## City of Sebastopol Design Review Board Staff Report

Meeting Date: May 20, 2020  
Agenda Item: 6a  
To: Tree Board  
From: Alan Montes, Associate Planner  
Subject: Tree Removal Permit  
Recommendation: Approval with Conditions  
Applicant/Owner: WJA Associates (Applicant)/Burbank Housing Development Corporation  
File Number: 2020-027  
Address: 699 Gravenstein Hwy North  
CEQA Status: Categorical Exemption: Section 15301: Class 1  
General Plan: High Density Residential (HDR)  
Zoning: Planned Community (PC)

The project applicant is seeking approval from the Tree Board for the removal of six (6) protected trees at 699 Gravenstein Hwy North, also referred to as the Gravenstein Apartments

TREE REMOVAL SITE PLAN

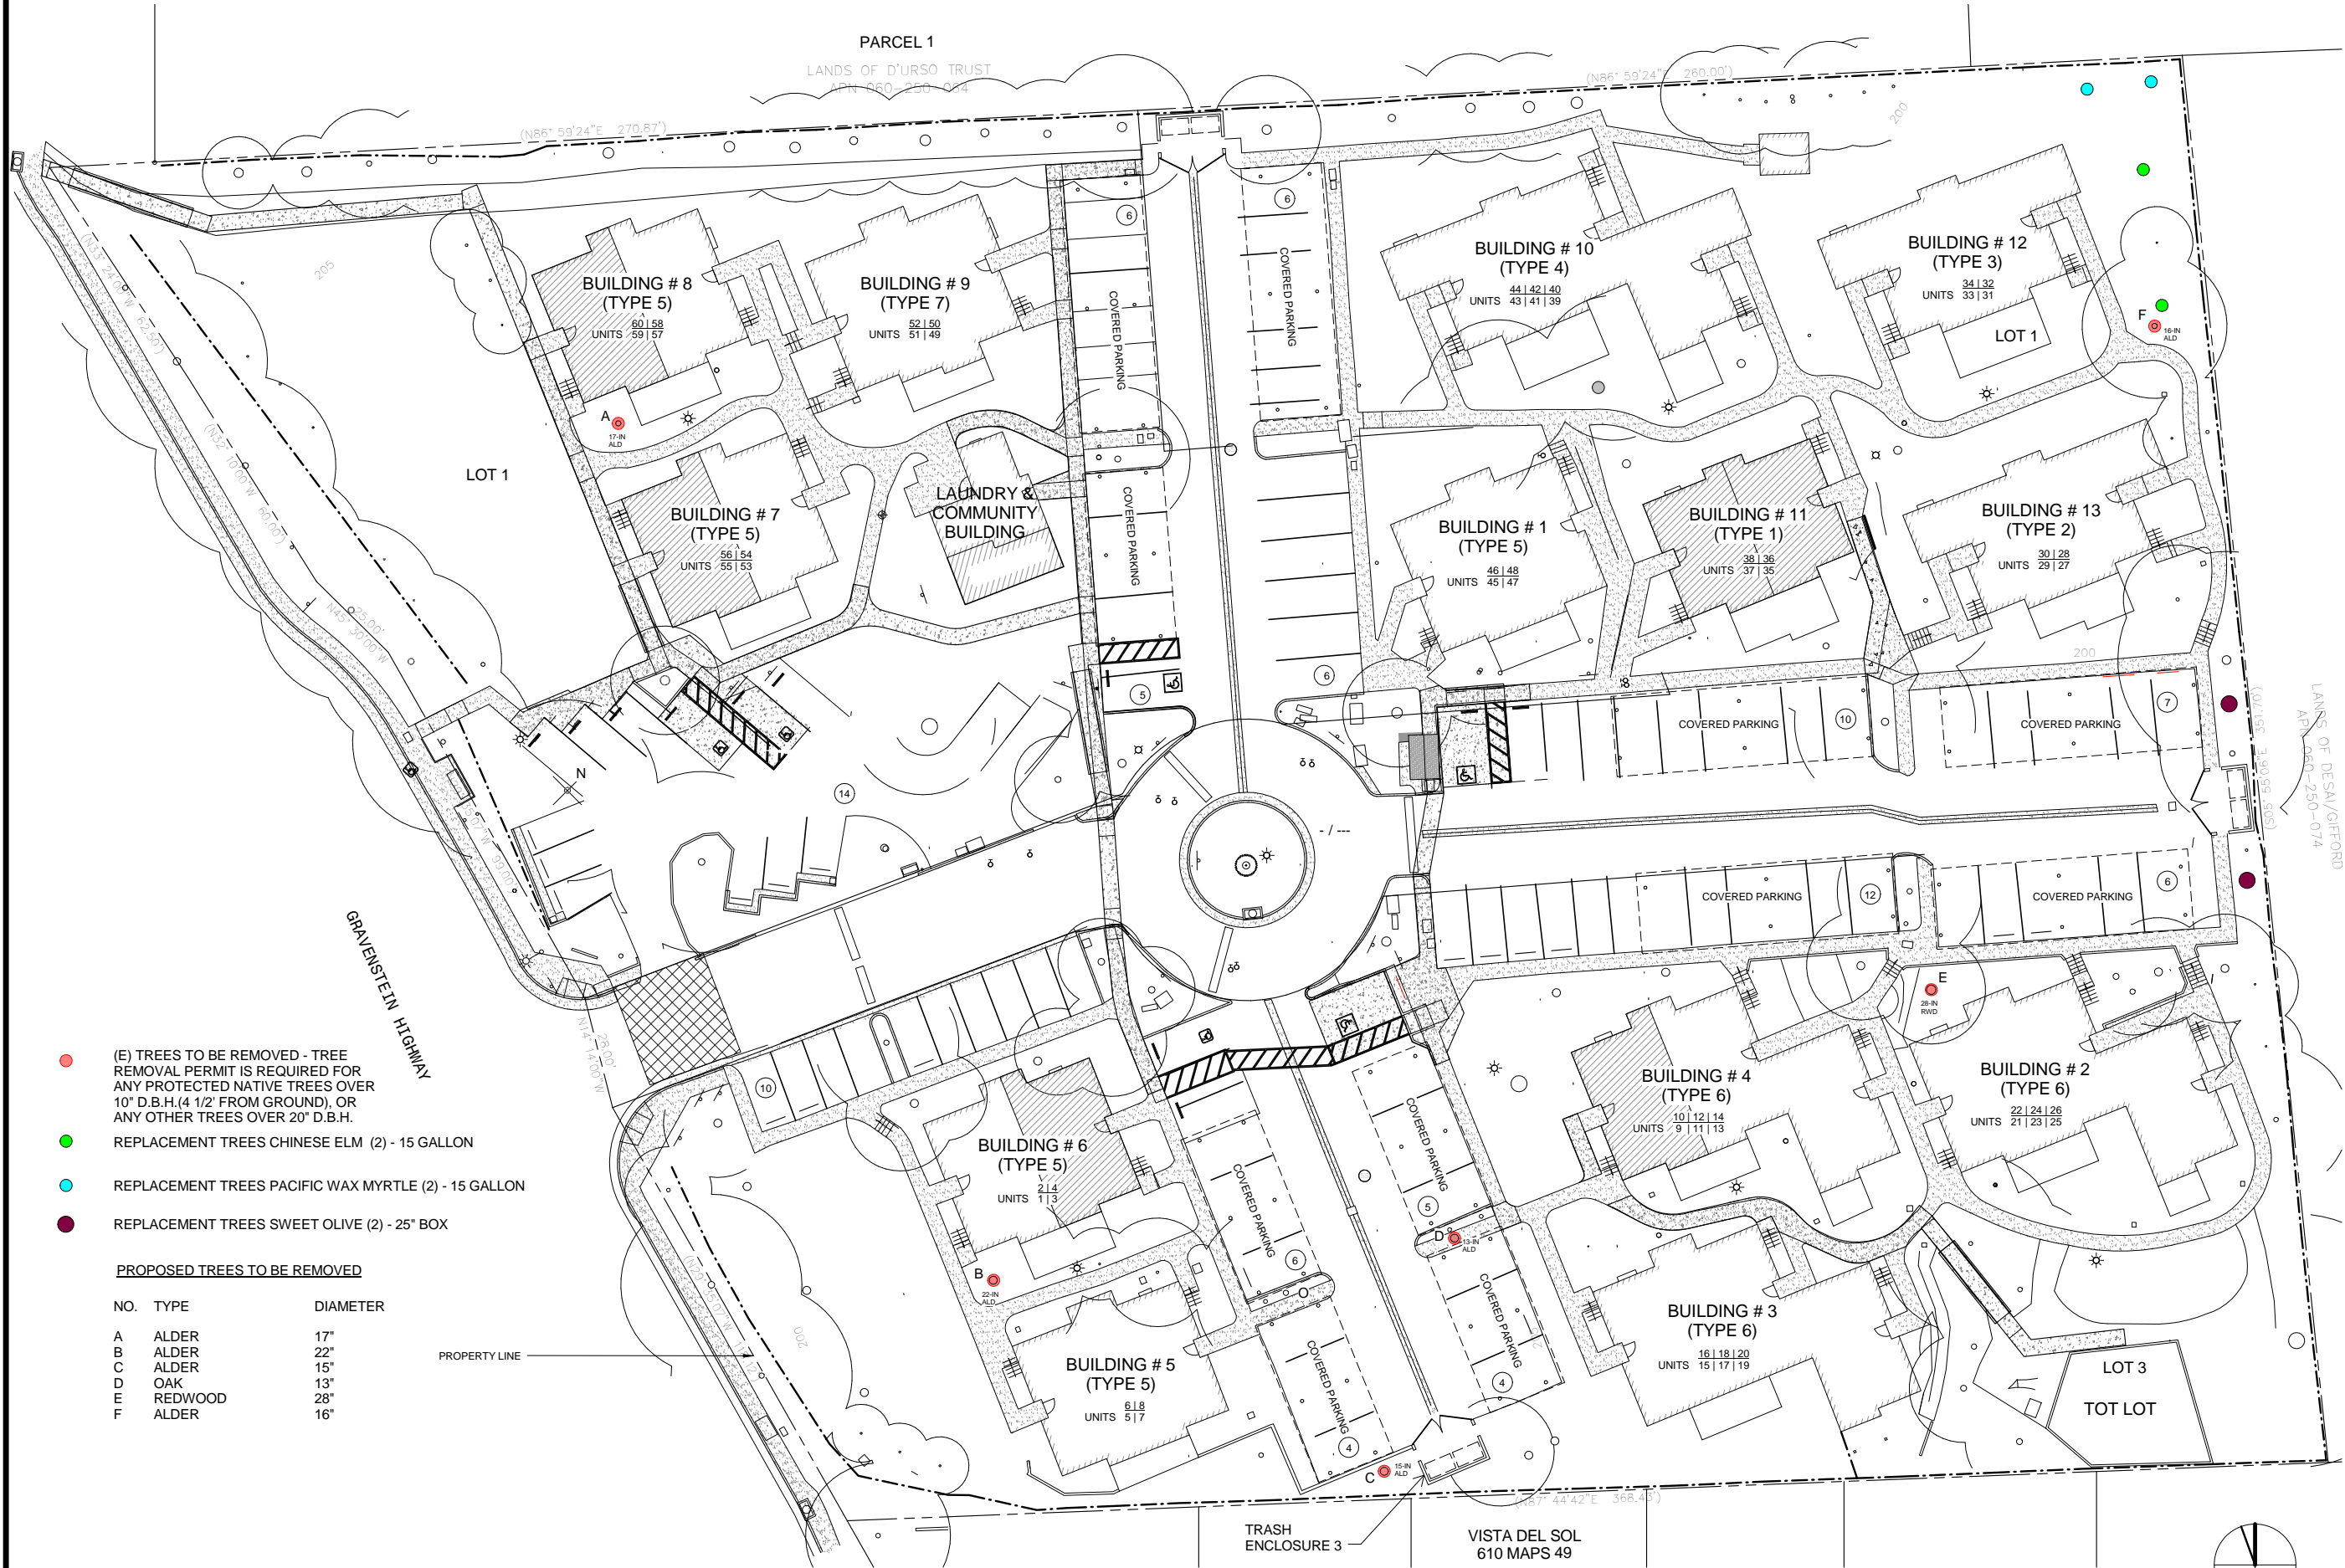
The application proposes removal of the following trees: one (1) redwood, four (4) alders, and one (1) oak tree. Trees proposed for removal are located throughout the site as shown in the site photos and site plan submitted by the applicant and included as attachments to this report. The applicant is seeking approval to remove the alder trees as they are diseased with bark beetle. Whereas the oak and redwood are causing damage to a building foundation and the lifting the parking lot asphalt.

Trees proposed for replacement include two (2) Chinese Elms, two (2) Pacific Wax Myrtle, both of which will be 15 gallon and two (2) 24" box sweet olive trees. The replacement plan is shown on the site plan submitted by the applicant. This represents a 1:1 replacement ratio, which is less than the required 2:1 replacement ratio generally required by the City. However, at the September 18, 2019 Tree Board meeting, the Board determined that the 24" container grown box trees may be counted as two (2) trees for this site as it was already heavily forested.

If the Board were to permit this provision for the current application, it would bring the replacement to eight (8) trees out of the required twelve (12) trees and require the applicant to pay an in-lieu fee for four (4) trees or \$300. Alternatively, the Board may determine that the remaining four (6) trees must be planted on-site if they feel this is best given the need to maintain tree canopy and resources on the site.

The final submittal of a tree removal application and replacement has been made by Burbank Housing and their architect, Elizabeth Putnam. The plan is dated 2/27/20. They had responded again to earlier suggestions of slight revisions to their plans to better protect existing trees. And they provided a plan showing replacement tree selections and locations. Locations have been selected for various reasons, shade, privacy screening, etc.

As described in my earlier reports, I have made several site visits, and the trees proposed for removal are causing significant damage to paving or structures, or are diseased, dying, or dead, and are reasonable candidates for removal and replacement.

1. The Tree Removal Permit for the removal of six (6) protected trees, as identified on the site plan, shall be valid for a period of three (3) years, except that the applicant may request a one (1) year extension of this approval from the Planning Director, pursuant to Section 17.400.100 of the Zoning Ordinance.

2. The applicant is required to plant six (6) replacement trees, two (2) of which are required to be 24" container grown box trees, as identified on the site plan and pay an in-lieu fee of \$300 for the additional four (4) replacement trees.

4. Prior to installation, location of replacement trees shall be determined by the City Arborist. Prior to planting replacement trees, the applicant shall obtain a letter from the City Arborist confirming the location and submit this to the Planning Department for review and approval.

IRRIGATION VALVE  
PLAN & NOTES

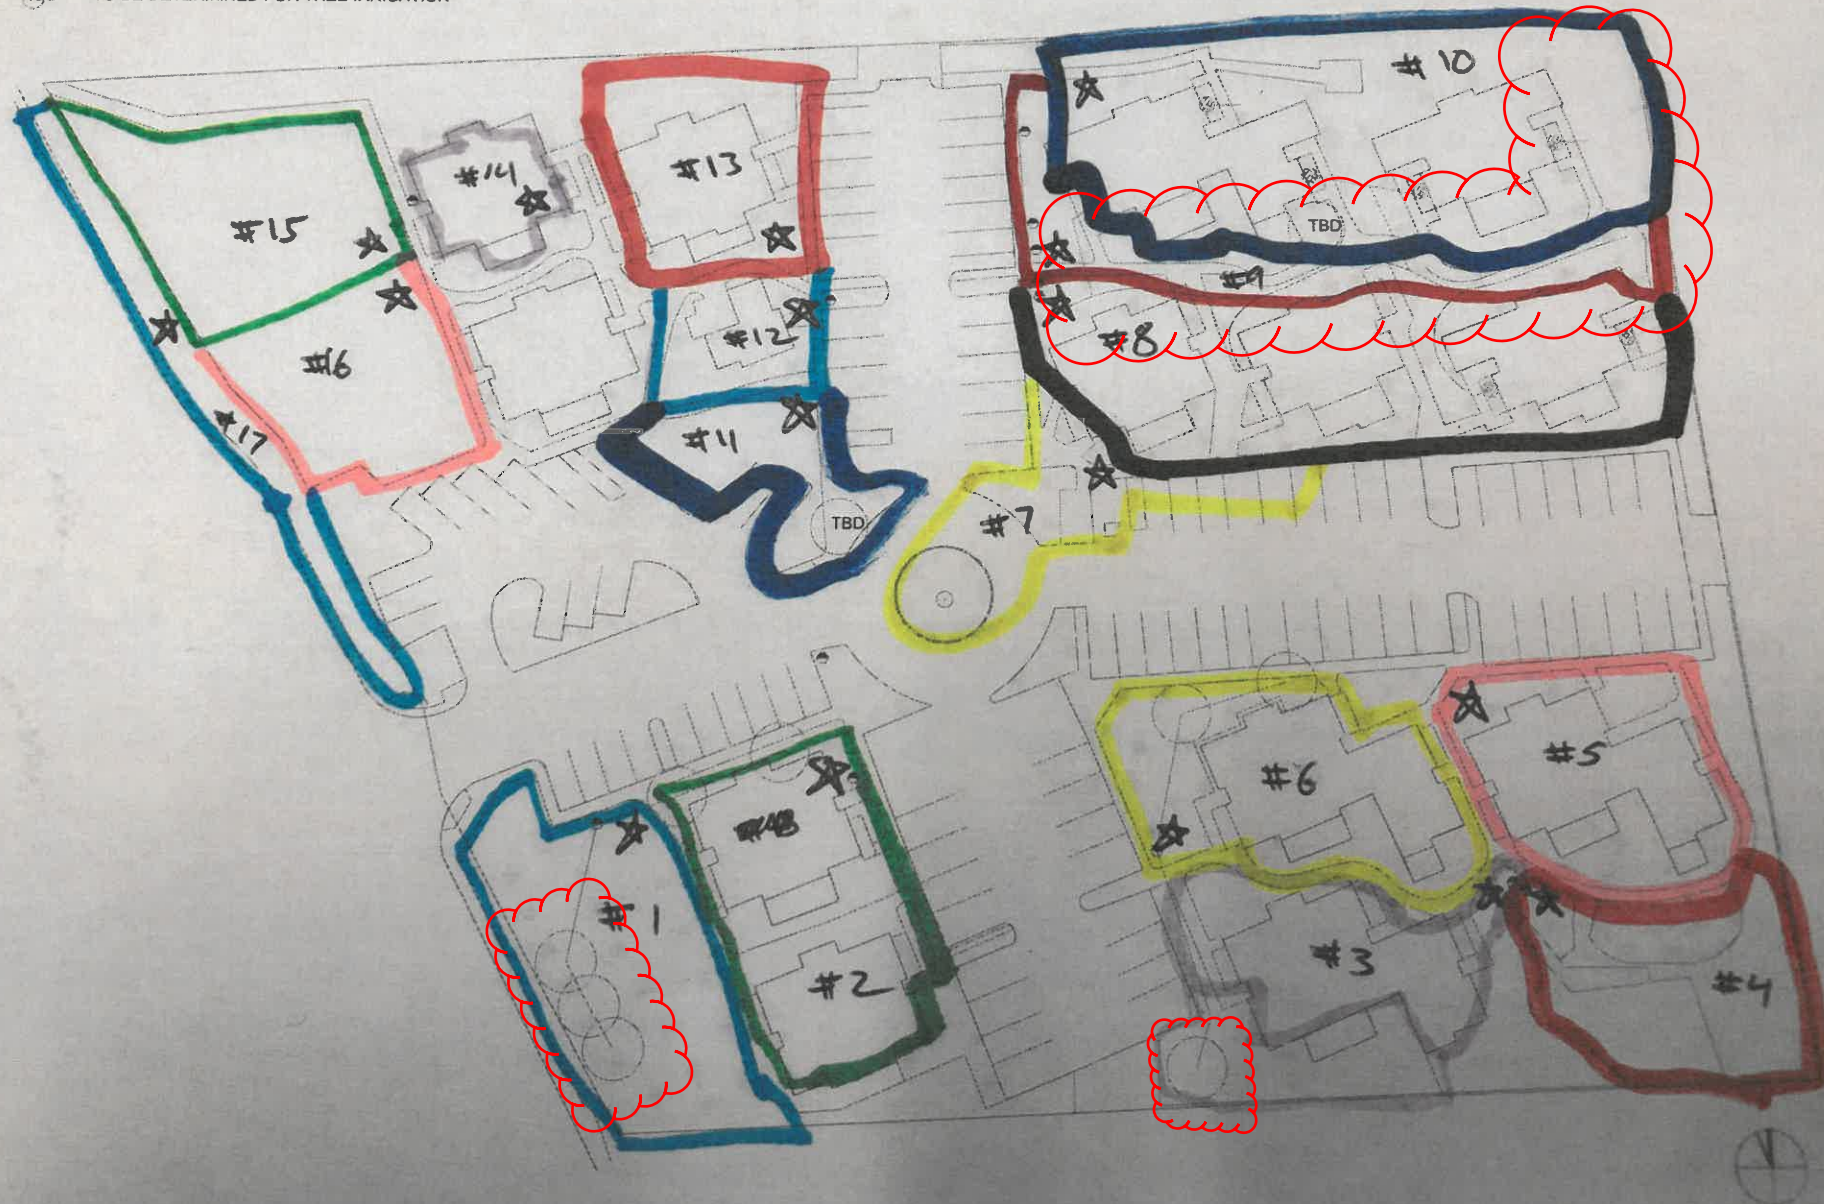
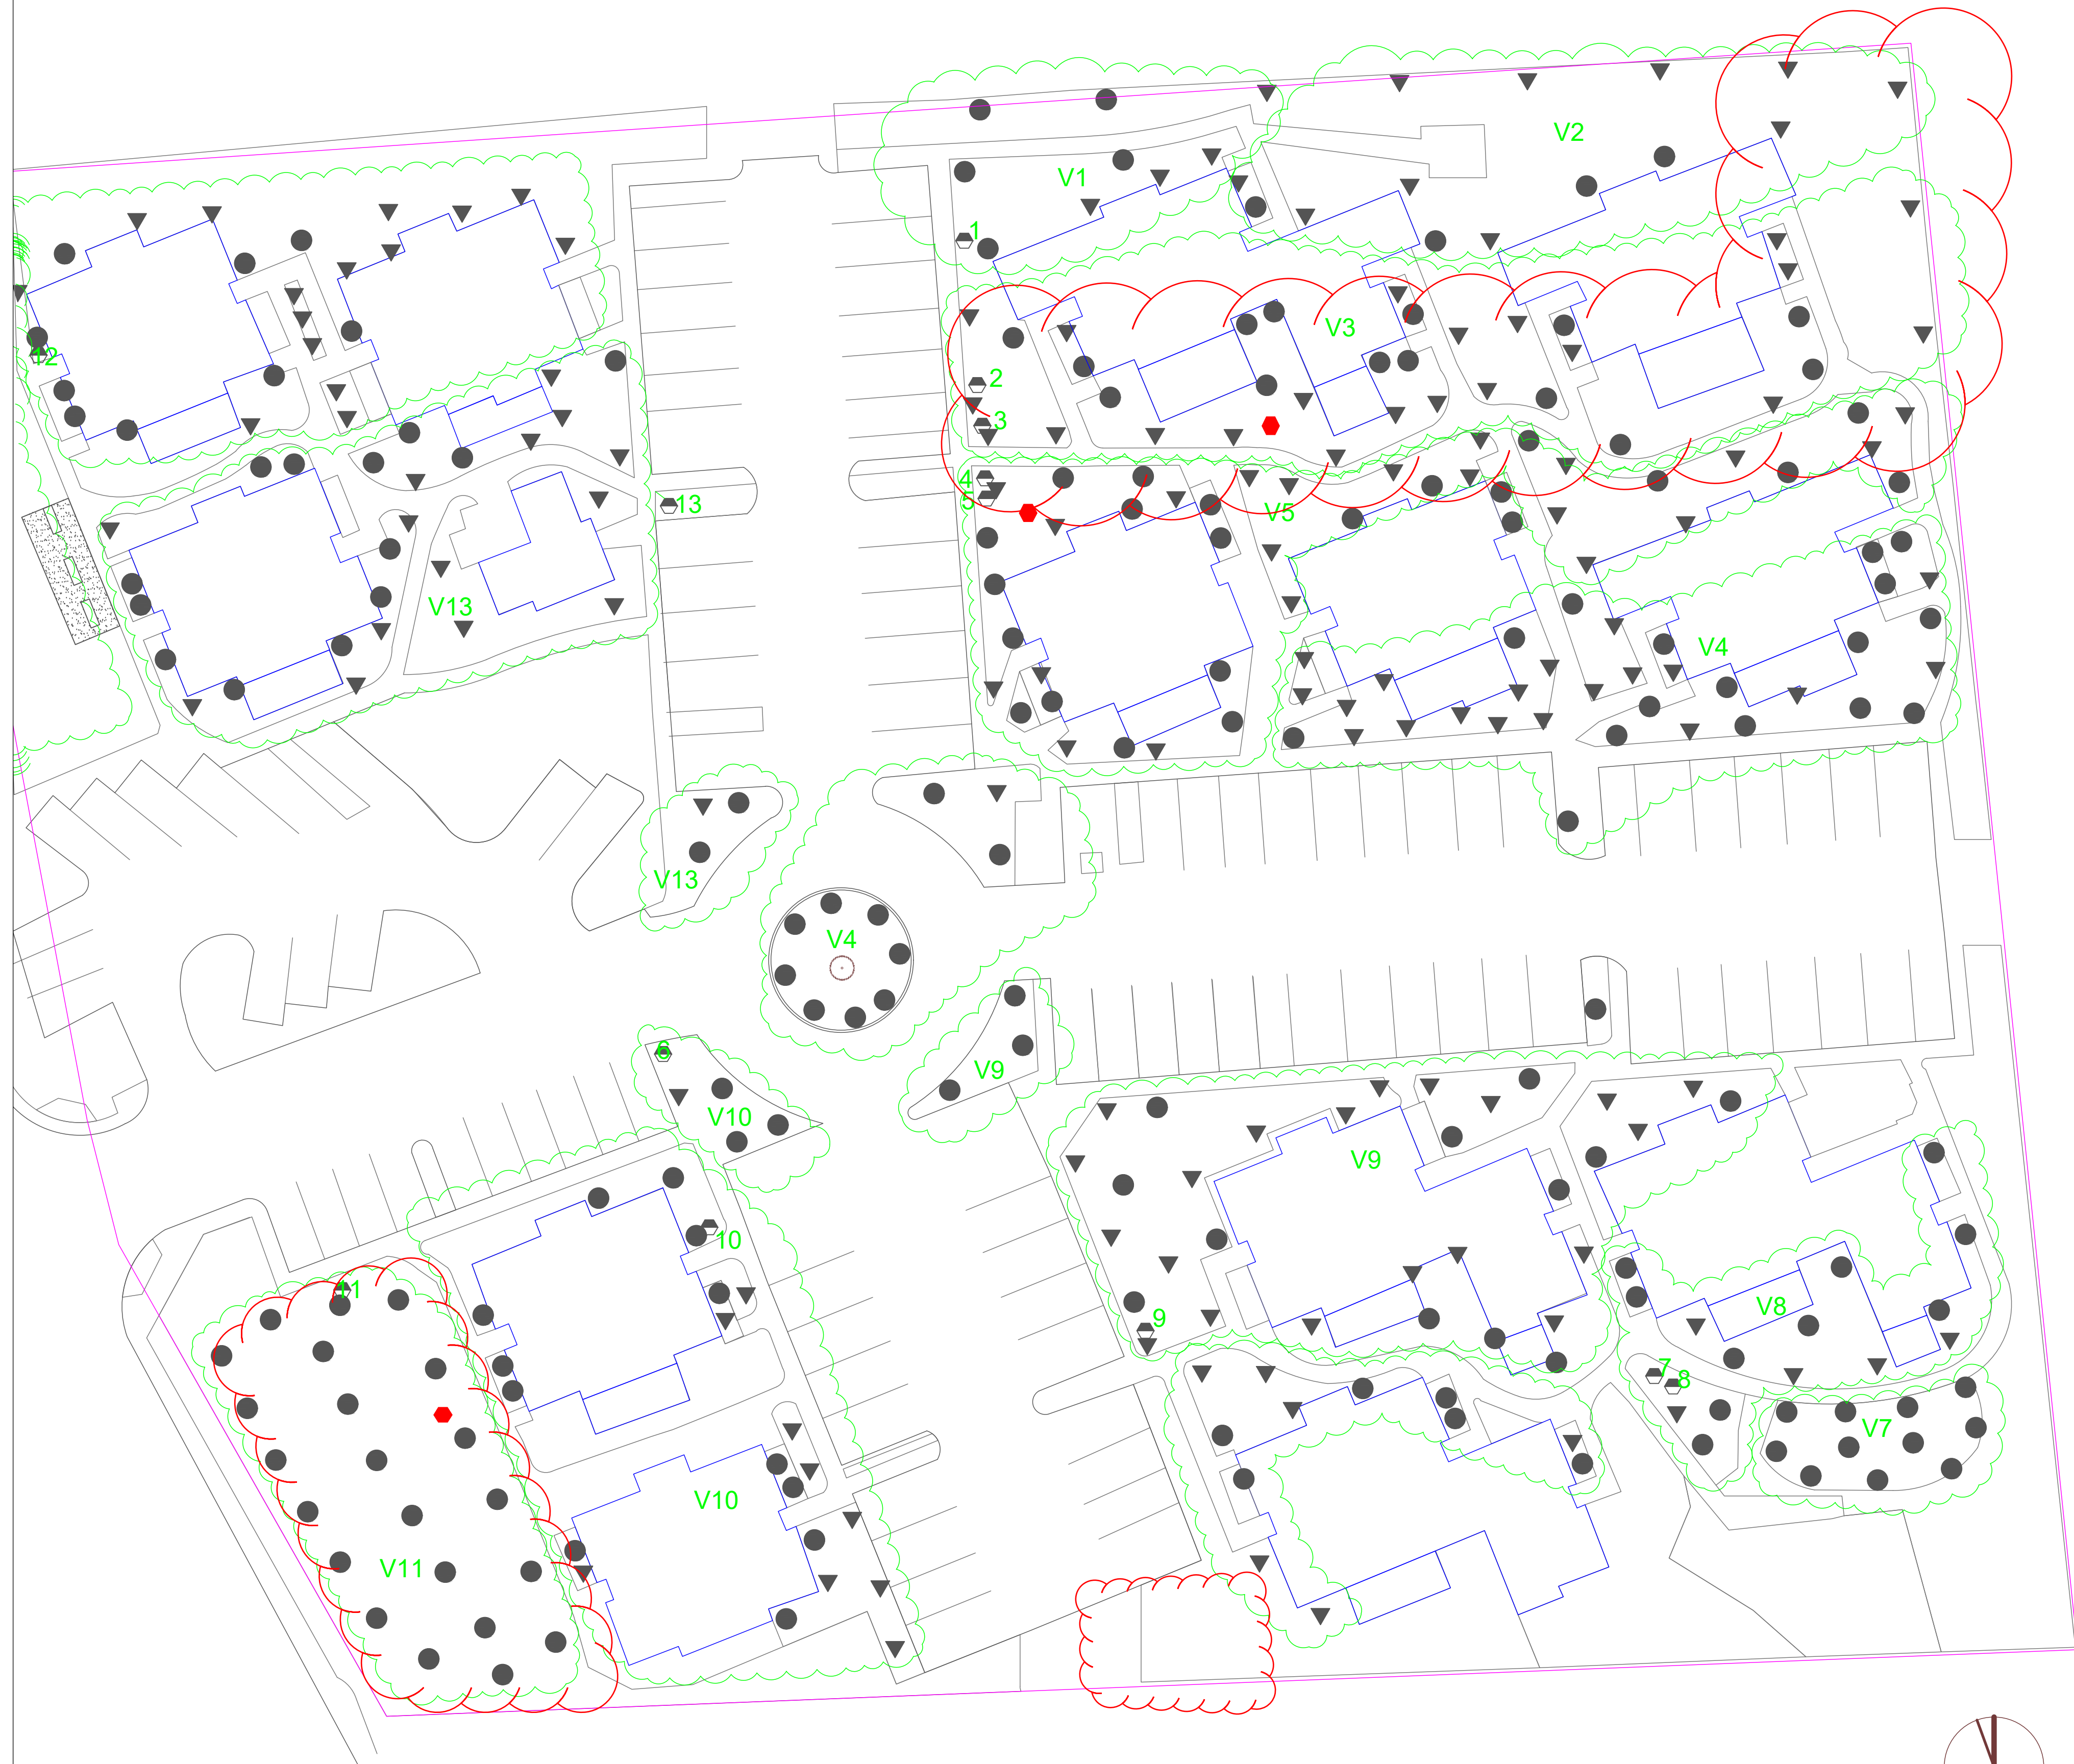
While the analysis by the City Arborist on the condition of the trees is clear, staff requested additional information regarding the replanting plan as well as irrigation/maintenance plans from the Applicant, based on prior reviews by the Tree Board and concerns regarding on-going care for the replacement trees. The Applicant has provided these and are included in the Attachments.

The applicant shall also confirm that replacement trees will be irrigated through an establishment period of 2-3 years, and describe and commit to the irrigation method – automatic sprinklers, Tree-Gator bags filled weekly (if unirrigated areas), hand watering by landscape contractor, etc.

3. Prior to planting, the applicant shall confirm that replacement trees will be irrigated through an establishment period of 2-3 years and describe the method of irrigation. This information shall be provided to the Planning Department for review and approval.

Proposed areas for replacement trees.  
Drip irrigation @ new trees to be controlled by dedicated valves.

Areas where replacement trees are to be planted.  
Final Location of trees per direction of City Arborist
